Water heater connection kit change

Old connecting copper pipe	New push fit coupling
 <p data-bbox="113 1413 379 1621">Old long connecting pipe with a straight connector joining the cold inlet pipe</p>	 <p data-bbox="815 1413 1082 1621">Push fit connector with cold inlet pipe pushed directly into coupling.</p>

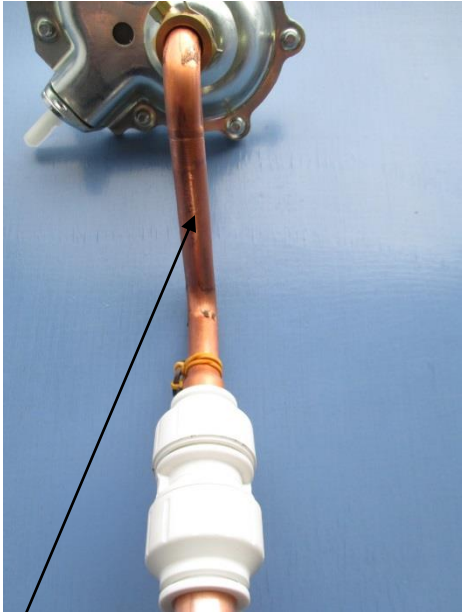
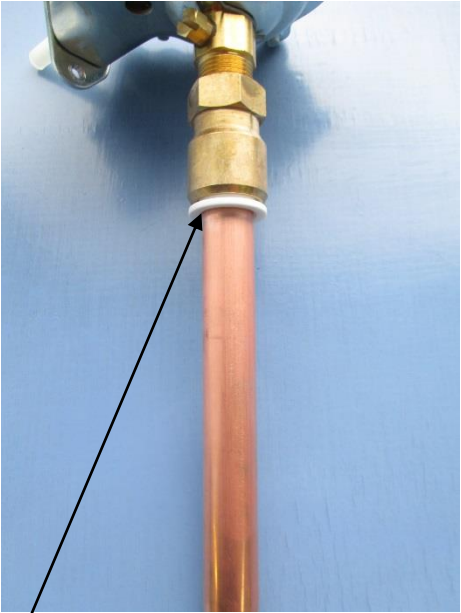
This connecting kit now excludes the long bent cold copper pipe which was the main link between the cold inlet pipe and water control assembly with the assistance of a 15mm straight connector.

This has been replaced by a push fit coupling which the cold inlet pipe now pushes directly into as highlighted below;
